PR/0723/22

Record of Executive Business and Chief Executive's Order

Reg. Reference: SDZ22A/0005 **Application Date:** 14-Apr-2022
Submission Type: New Application **Registration Date:** 14-Apr-2022

Proposed Development: Phase Three of the Adamstown District Centre and consists of 37,402sq.m (gross floor area including car parking and storage) of residential development to be constructed in 3 blocks ranging in height from 2 to 9 storeys; There is a total of 436 apartments, comprising 9 studio apartments, 204 one bedroom apartments, 213 two bedroom apartments and 10 three bedroom apartment; An ancillary resident's pavilion building (2 storey) is linked to Block D, ancillary resident's amenity rooms and facilities are also provided at ground floor level of Block A; All apartments are provided with private open space in the form of balconies or gardens; The proposed block description is as follows: Block A (c. 11,821sq.m gross floor area): 4 - 5 storeys in height, with a total of 143 apartments (70 one bedroom apartments, 67 two bedroom 4 person apartments and Gno. 3-bedroom apartments); A resident's only podium level, courtyard is provided within Block A; Ancillary plant, storage,

Figure 3 Cross section of West Street.

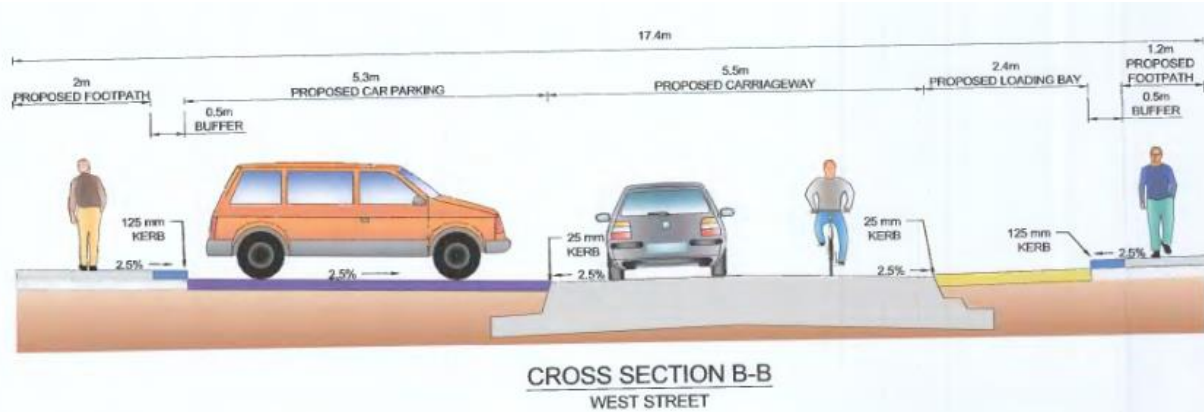
The submitted cross section of West Street shown in Figure 3 detail the footpath width at 1.2m this must be 2.0m at a minimum.

3.
 - a. The applicant is requested to submit a revised layout not less than 1:200 scale showing the minimum width of footpaths at 2.0m wide.
 - b. The applicant is requested to submit a revised layout not less than 1:200 scale showing a turning location at the dead end in the car park of Block A, as per road safety audit.
